Subject: Re: FW: FW: Pound Place A/18/20/DOC

Engineers Comments Regarding Surface Water Drainage

At present we are not able to recommend that condition 3 is discharged. Please address the following points, the majority of which will enable a contractor to be able to construct the scheme from the plans with confidence. Points 1 and 2 may influence the nature of the design and require immediate attention if work is due to or has already commenced on site (bearing in mind that this is a pre-commencement condition).

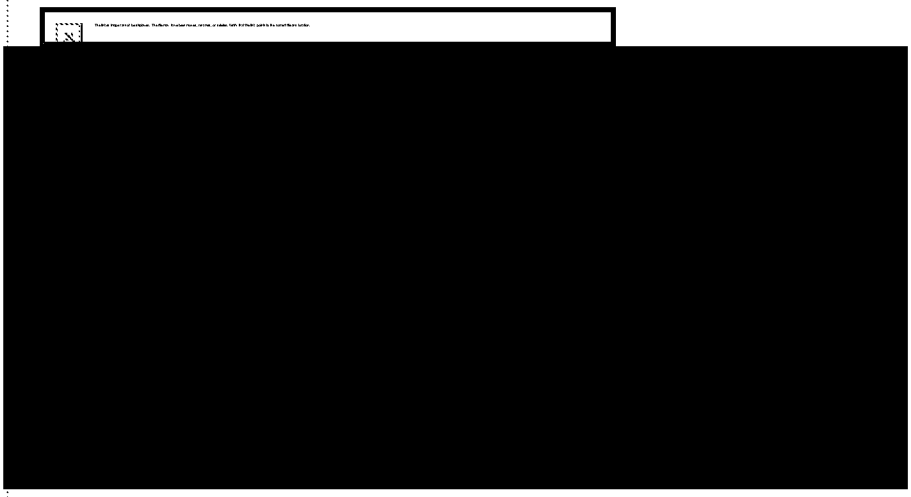
12: Soakaway detail shows pipes at the top of the soakaway, which we agree with. However on the plan the invert levels are the same as the base level, implying that they come in at the base. Please adjust. Infiltration detail is typical with exact levels, dimensions and pipe configuration shown on the

12. The detail does not need to be site specific for the same reasons that only typical manholes, petrol interceptors, Hydrobrakes etc. are drawn with key information that varies between each unit or group of units provided in table form. The key information specific for each groups of cellular units / soakaway is provided in a summary table on the drainage plan adjacent each soakaway. The drawing has been amended to make these more clear.

The depth of water in the soakaway units for SCS1 -SCS4 in order for the 10yr event is 0.428, 1.036, 0.900, 0.492m. As the crates are 0.4m high with an inlet at its base and midpoint, units SCS1 & SCS4 have been adjusted so the inlet is 0.6m from the base and SCS2 & SCS3 set 1.2m from their base. The notes on the drainage plan listing their key information has been amended accordingly.
